United States Department of the Interior

FISH AND WILDLIFE SERVICE

July 11, 1984

FWS Log No. 4-1-84-229

Figure 1. Red-cockaded Woodpecker colonies in Georgia: 1966-1980.

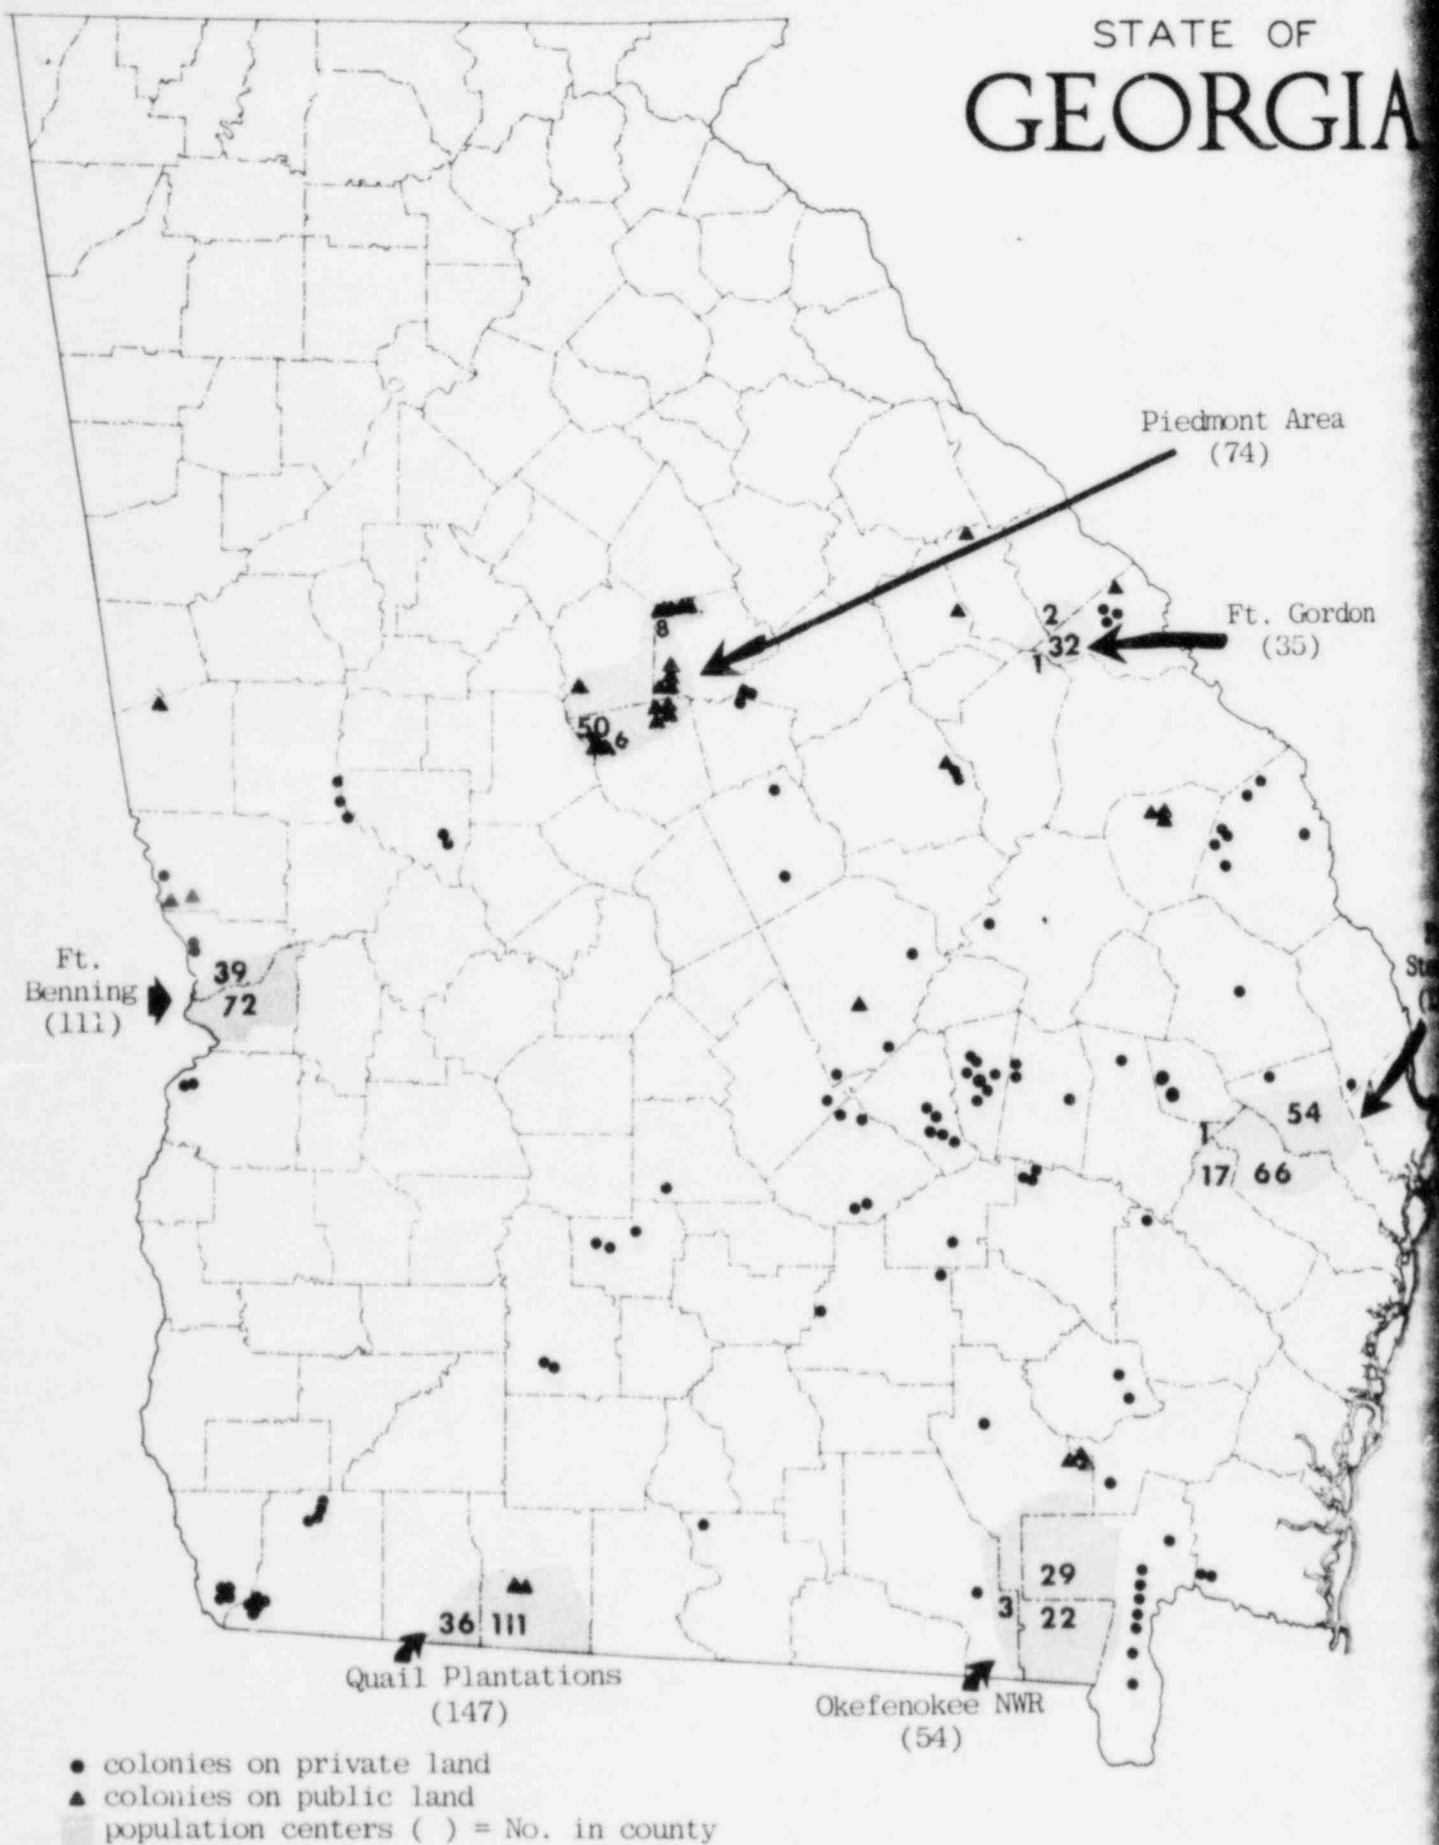
We suggest that during the evaluation of the transmission line corridor, the status of the red-cockaded woodpecker be determined. We have enclosed a map showing the known colony sites, however, others may exist in this area.
